## RESPONSE TO COMMENTS

### Jug Mountain Ranch LLC NPDES Permit ID0028029 June 25, 2019

On April 4, 2019, the U.S. Environmental Protection Agency (EPA) issued a public notice for the reissuance of the Jug Mountain Ranch LLC wastewater treatment plant National Pollutant Discharge Elimination System (NPDES) Permit No. ID0028029.

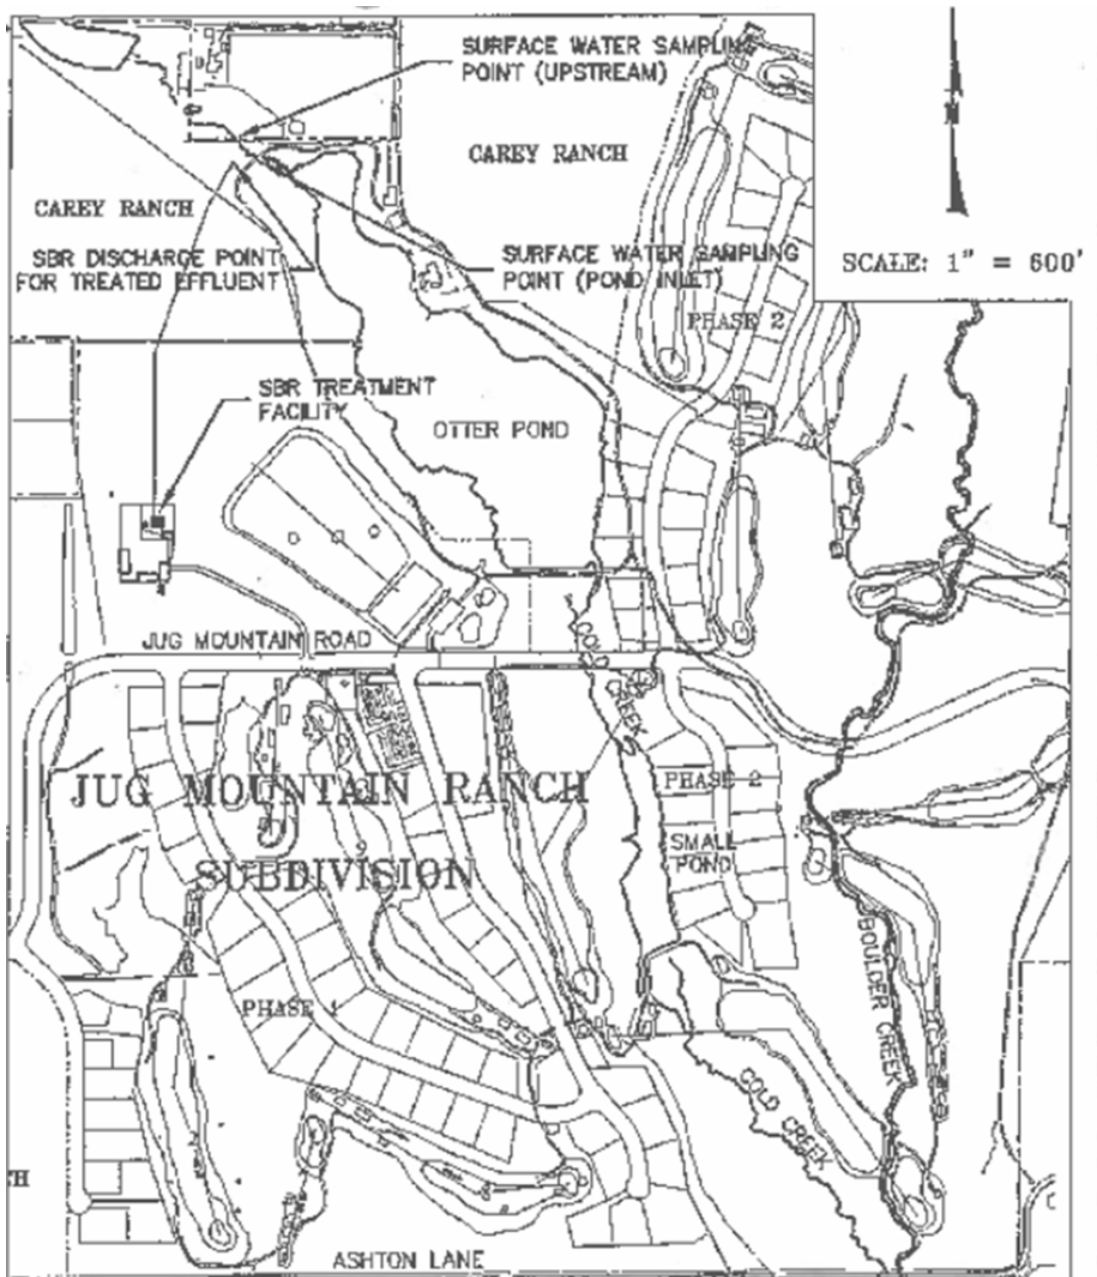
4. **Comment (Jug Mountain):** I would also like to provide you with a general description of the property and the SBR system, in order to give you a better context for the reasonableness of the request for an increase in the TSS limits. Jug Mountain Ranch Planned Unit Development (“JMR PUD”) is a project consisting of approximately 1,430 acres, 1,104 of which are approved for platted recreation / open space. Boulder Creek is the principal stream which courses through the JMR PUD. Cold Creek, which is a small tributary of Boulder Creek, also flows through the JMR PUD. Cattle grazing on 670 acres of the JMR PUD has been eliminated, and Forest Land Improvements have been implemented. 7600 linear feet of streambank stabilization has been done along Boulder Creek.

The outflow from the SBR treatment facility is correctly stated in the Fact Sheet at Section III.A, Outfall Description. However, following is a description that includes a bit more detail regarding the outflow from the SBR treatment facility to Cold Creek: The outflow from the SBR treatment facility passes through a pipe approximately 400 yards long into the bottom of a manhole. The solids settle in the bottom. As the water level rises it flows out through a pipe into a gravel drainfield. Once the effluent passes through the gravel drainfield it enters a wetland.

The effluent moves from the wetland into Cold Creek above Otter Pond, which then flows into Otter Pond itself. The upper end of Otter Pond is very shallow and is inundated with cattails. Otter Pond is a 25+ surface acre pond that is approximately 25 feet deep behind the dam. From the upper end of Otter Pond (aka Pond Inlet) it is 600+ yards to the top of the spillway at the bottom of Otter Pond, providing the solids ample opportunity to settle out prior to moving downstream. The water level rises and passes over a spillway entering a wetland thick with cattails and into the Small Pond that is 10+ acres in size and shallow. From the Small Pond the water re-enters the creek and flows 500 yards through another heavily vegetated narrow stream before leaving the property and connecting with Boulder Creek south of Ashton Road. Although JMR LLC is not required to test for TSS in the surface water monitoring, we believe (given the description above), that any suspended solids contained in the effluent discharge have settled/filtered out long before any discharge reaches Boulder Creek.

Further mitigating any negative impact to Boulder Creek is the fact that, between the combination of summer usage and late fall draining of Otter Pond, water does not pass over the spillway for a majority of the year. Otter Pond is the source of irrigation for the golf course. During the growing season (late May through mid-October) JMR LLC can use up to 3 acre feet of water per day (326,000 gallons of water per acre-foot). During JMR LLC’s peak irrigation season, water does not pass over the spillway at the bottom of Otter Pond. JMR LLC diverts water from the Carey Ranch Irrigation system into the pond to maintain adequate levels once spring runoff ceases. Also, during late fall, JMR LLC drops the level of Otter Pond well below the bottom of the spillway. This provides protection from an unexpected flush of water from runoff or a mid-winter thaw. In February of 2019, the Otter Pond level was in excess of 10 feet below the top of the spillway.

**Response:** The point of compliance with the TSS effluent limitations is the wastewater in the dose tank after the treatment system and before it is pumped to outfall 001.

Cold Creek is the receiving water for the discharges from Jug Mountain as shown below:

Cold Creek at the point of discharge must be protected for its designated uses. The TSS limits are technology-based limits based on what the treatment system can achieve and must be achieved at the point of compliance to protect the designated uses of Cold Creek.

The effects of the manhole, wetland and instream treatment by Otter Pond are not relevant to the performance-based TSS limits established to protect Cold Creek.
